Access Compliance Report

Public Rights-of-Way

(Curb Ramps)

Intersection ID: 10038380	Main Street: SOUTH_BV	Cross Street: N/A	Location: SE
ADA ID: 66EEB9366B15	Ramp Type: Perp	Initial Pass/Fail: Fail	Overall Compliance: No
Codes/Mitigation Info/Possible Solution		Field Measurements/Component Compliance	
Severity Score: 25

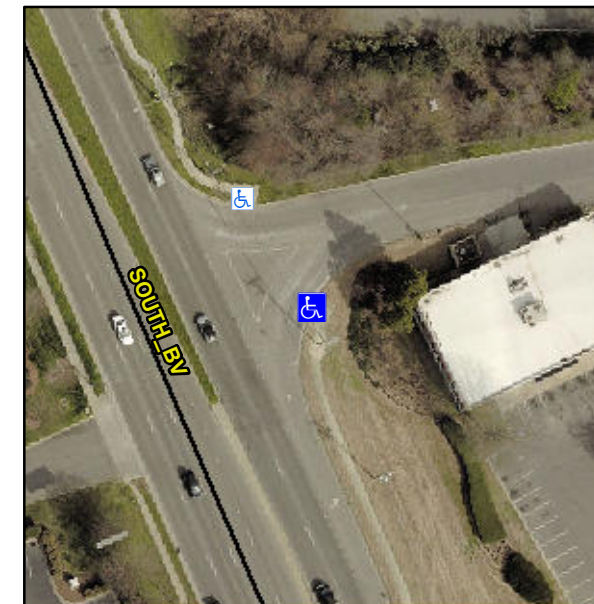
Not Found, R304.2.2

Compliance	Description	Data	Compliance	Description	Data
N/A	Ramp Length (in)	121.0	No	Ramp Slope (%)	12.5
Yes	Ramp Width (in)	48.0	Yes	Ramp XSlope (%)	1.6
N/A	Flare Type LT	N/A	N/A	Flare Type RT	N/A
N/A	Flare Slope LT (%)	N/A	N/A	Flare Slope RT (%)	N/A
N/A	Flare Traversable LT?	N/A	N/A	Flare Traversable RT?	N/A
N/A	Landing Length (in)	N/A	N/A	DWS Provided?	N/A
N/A	Landing Width (in)	N/A	N/A	DWS Contrast?	N/A
N/A	Landing Slope (%)	N/A	N/A	DWS Length (in)	N/A
N/A	Landing X Slope (%)	N/A	N/A	DWS Full Width?	N/A
N/A	Landing Curb? (Y/N)	N/A	N/A	DWS Offset (in)	N/A
N/A	Shared Landing?	N/A			
N/A	Gutter Ponding?	N/A	N/A	Gutter Slope (%)	N/A
N/A	Gutter Lip Ht (in)	N/A	N/A	Gutter X Slope (%)	N/A
N/A	Painted X Walk1?	No	N/A	Painted X Walk2?	N/A
	X Walk 1 Direction	To N		X Walk 2 Direction	N/A
N/A	X Walk 1 Width (in)	N/A	N/A	X Walk 2 Width (in)	N/A
	X Walk 1 Slope (%)	0.1		X Walk 2 Slope (%)	N/A
	X Walk 1 X Slope (%)	0.3		X Walk 2 X Slope (%)	N/A

Remove & Replace Entire Ramp.
